**DEFIANCE COUNTY COURTHOUSE**  
**Addition and Alterations**  
Defiance, Ohio

C3-4890

**ADDENDUM 3**

6 **ELEVATOR PIT ACCESS LADDER**  
AE110a 1/4" = 1'-0"

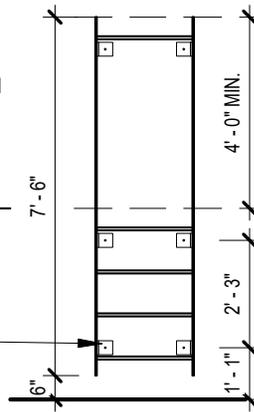
**ITEM NO. 10: Sheet AE110 – Basement and Annex Plans**

Refer to attached Addendum Drawing AE110a for elevator pit access ladder detail.

L8x4x1/2" x4" LONG,  
WELD TO LADDER,  
FASTEN TO WALL  
WITH 1/2" DIA. BOLTS

3/4" DEFORMED STEEL  
ROD AT 12" O.C. MAX.

CONFIRM DIMENSIONS WITH  
ELEVATOR MANUFACTURER
